TECHNICAL EVALUATION REPORT

EVALUATION OF SPENT FUEL RACKS STRUCTURAL ANALYSIS

CONSUMERS POWER COMPANY
PALISADES PLANT

TER-C5506-650

Figure 3-13. Nonlinear Seismic Model

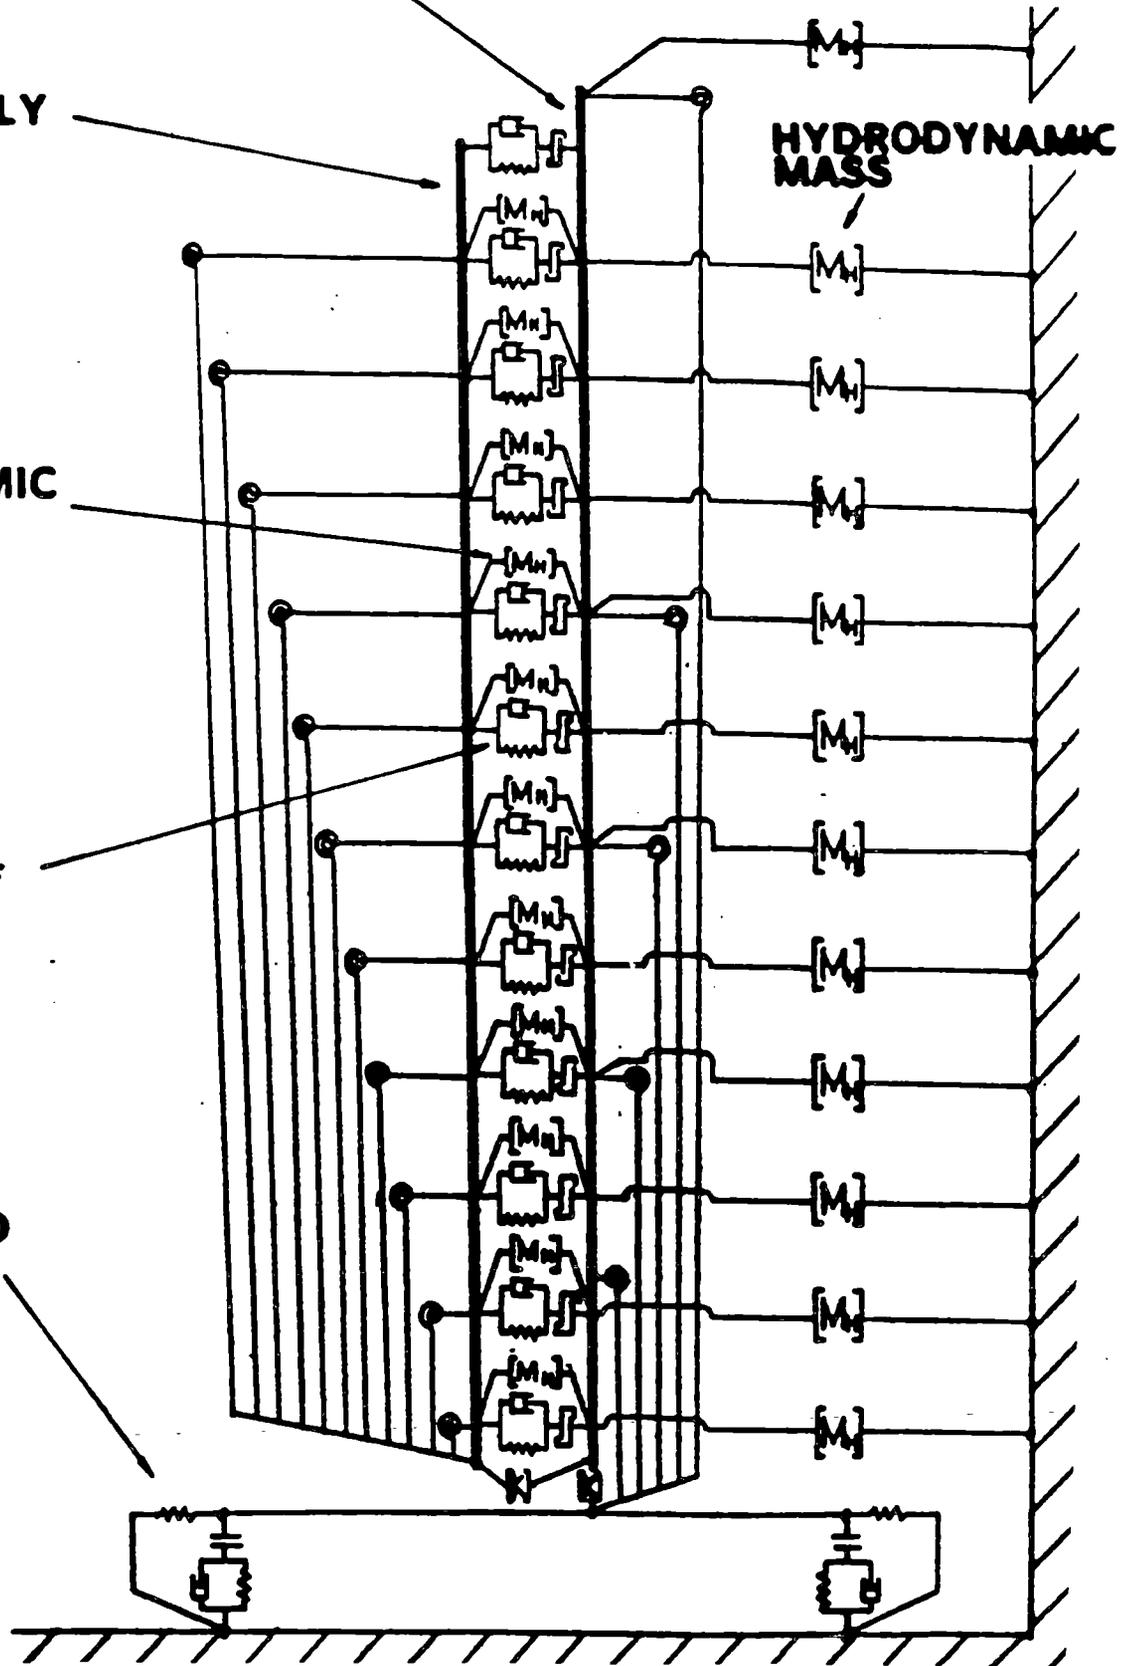
The assumptions listed above were found to be acceptable in general. It should be noted, however, that effects of torsional moments due to partially loaded racks were not captured by the two-dimensional nonlinear seismic model. Based on seismic analysis results and using best engineering judgment, it has been concluded that ignoring torsional moment effects would not influence the overall conclusions.

The maximum pad (mounting foot) lift-off from the pool floor is 0.342 inches. This pad was modeled using an impact/gap element (see Figure 3-13) which allows impact to be accounted for in the dynamic analysis. The loads developed from this dynamic analysis were, in turn, used in the stress analysis.

Figure 3-14. Structural Model of Typical Fuel Rack

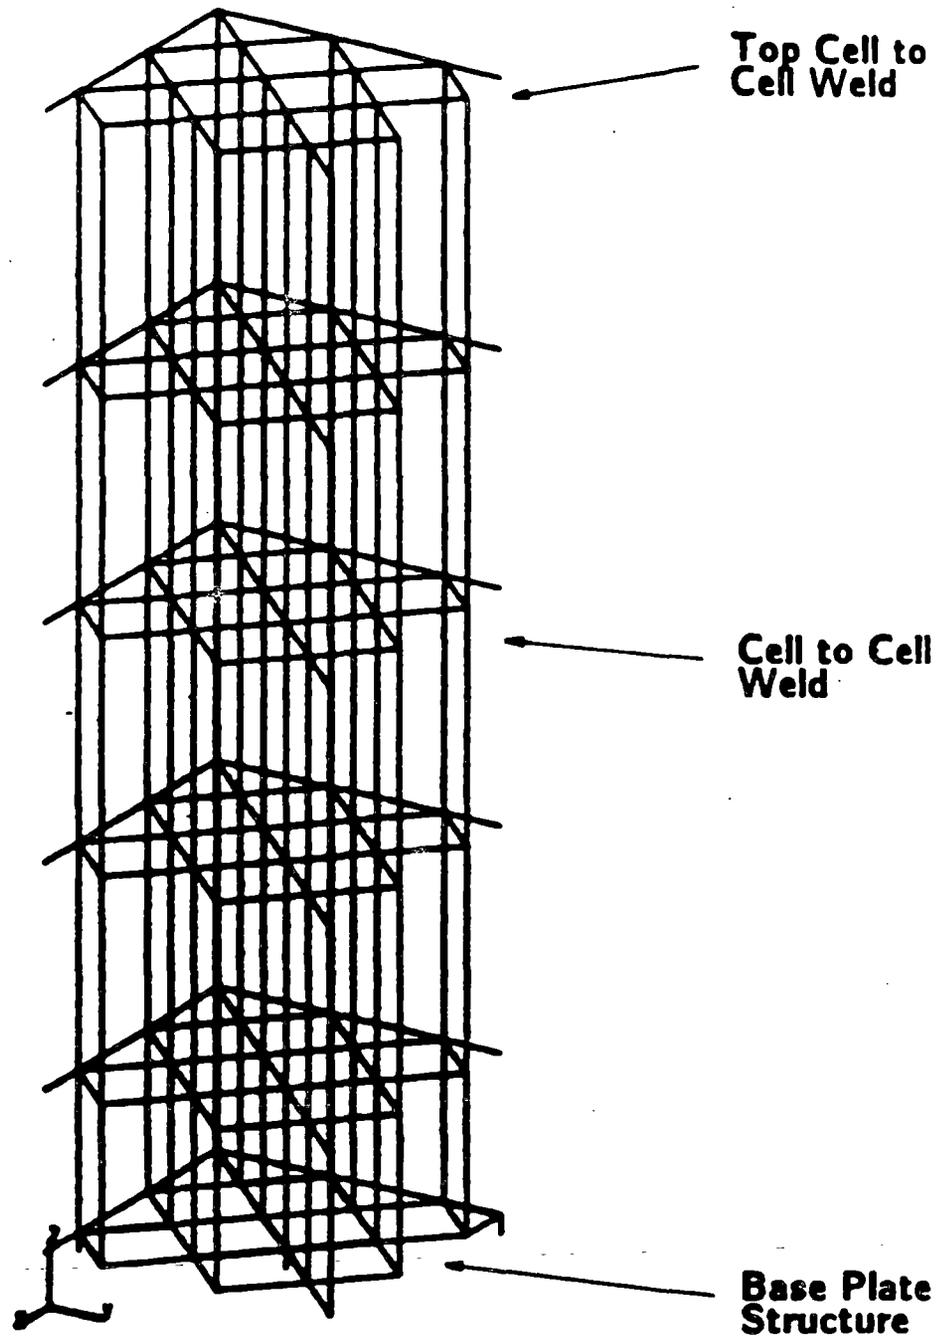
The structural model, shown in Figure 3-14, is a finite element representation of the rack assembly consisting of beam elements interconnected at a finite number of nodal points, and general mass matrix elements. The beam elements represent the beam action of the cells, the stiffening effect of the cell to cell welds, and the supporting effect of the support pads. The general mass matrix elements represent the hydrodynamic mass of the rack module. The beams which represent the cells are loaded with equivalent seismic loads and the model produces the structural displacements and internal load distributions necessary to calculate the effective structural properties of an average cell within the rack module. In addition, the stiffness properties and the internal load and stress distributions of this model are used to calculate stress peaking factors to account for the load gradients within the rack modules.
